Historic Zoning Commission

July 17, 2025

Agenda

SITE PLAN

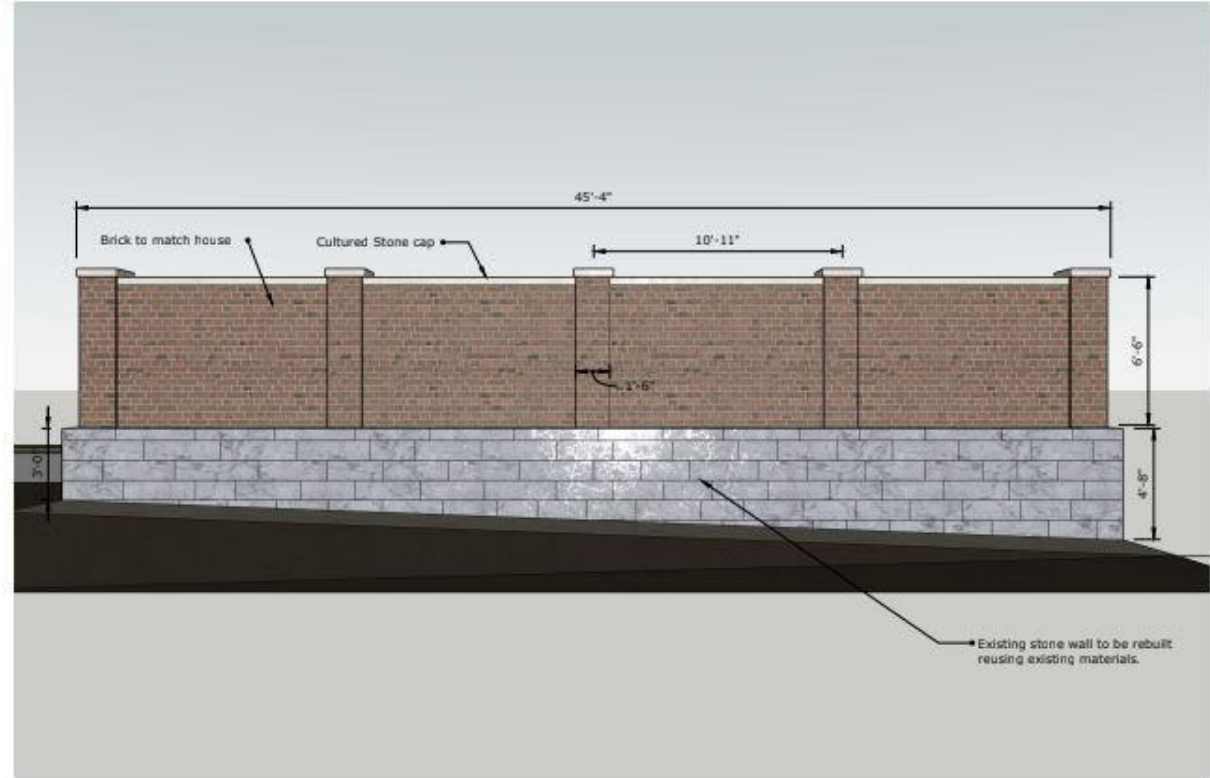
The applicant is proposing to rebuilding both retaining walls. The rear brick wall will be new materials (applicant to confirm) and the wall along Fort Wood Place will reuse the existing stone, but be in a new location.

4. The design of new fences and walls should blend with materials and designs found in the district and on the property. Commonly used materials are limestone, brick, concrete, and iron. Less common are wood and shrubbery hedges. The applicant is proposing to reuse some materials and rebuild the brick wall with new brick and a cultured stone cap.

6. The height of the fence or wall should not exceed the average height of other fences and walls of surrounding properties and generally should not exceed 3.5 feet in the front or 6 feet in the rear. Both walls exceed 6' on the side and rear. The wall along Fort Wood Place will be 11' 2" and the rear wall will be 7'. Applicant to confirm existing height of walls.

Front Elevation Changes (East)

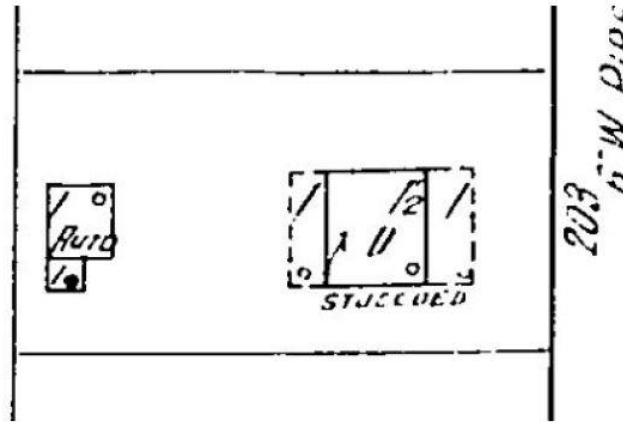
- 1: Change single window (left side) to triple window that mimics the original one to the right of the front door. The single window that is removed will relocate to the left elevation. New window to be wood clad, simulated divided lite.
- 2: Change dormer material from asbestos siding to real cedar shake.
- 3: Remove vinyl shutters from all windows and replace shutter on dormer only with wooden, operable style with dogs.
- 4: Replace existing metal chimney cap with clay cap that is more period correct.

Left Elevation Changes (South)

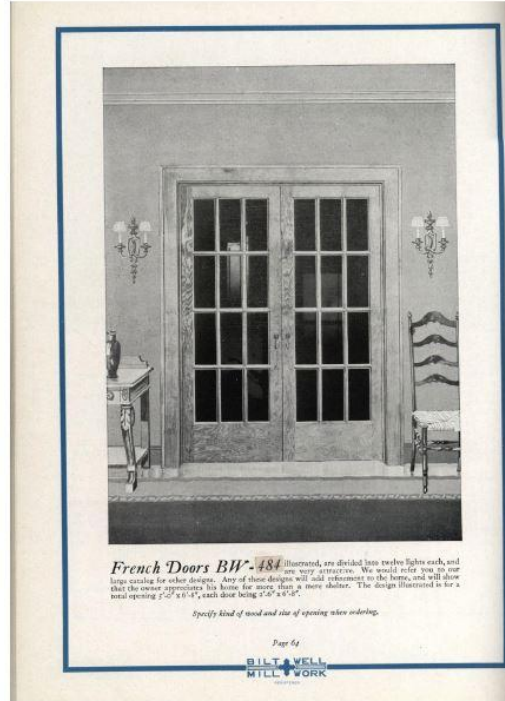
- 1: Change dormer material from asbestos siding to real cedar shake.
- 2: Single window relocated from the front moves to side of breakfast room (front right).
- 3: Remove 1960s railing and replace with wood balusters and 6"x6" wood columns.
- 4: Exchange center window position with right window position.

5. Plastic or metal strip awnings or non-original shutters that detract from the character and appearance of the building should not be used.
6. **New window and door openings should not be introduced. The applicant is proposing to install multiple new door and window openings. Applicant is proposing a new front window on the front elevation that was previously an open porch and french doors on to the existing porch on the front elevation. Applicant is proposing two new windows on the east elevation at the rear and one new window on the south elevation at the rear.**

Ex: Differing material in dormer— Proposed cedar shake

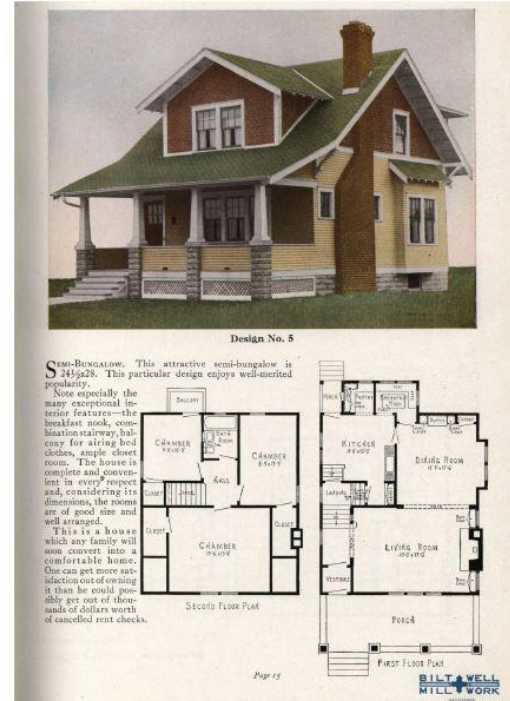
1. Original building material (wood, brick, mortar, stone, terra cotta, and stucco) should be retained. **The applicant is proposing to install cedar shake siding on the existing dormer. The applicant provided examples from a period appropriate home catalog showing the cedar shake siding as a relevant material. The home catalog also shows a clay chimney cap. The applicant is proposing to replace the metal chimney cap with a clay cap.**

3. Vinyl siding or other synthetic siding should not obscure character defining elements of the structure, such as roof trim and window surrounds.
4. Replacement wood siding should be consistent with the original in size, direction, and lap dimension. Diagonal siding should not be used. Vertical siding should not be used unless the original siding was vertical. Original wall shingles should be maintained where possible, or replaced with compatible material. **The applicant is proposing to install cedar shake siding on the existing dormer. The applicant provided examples from a period appropriate home catalog showing the cedar shake siding as a relevant material.**
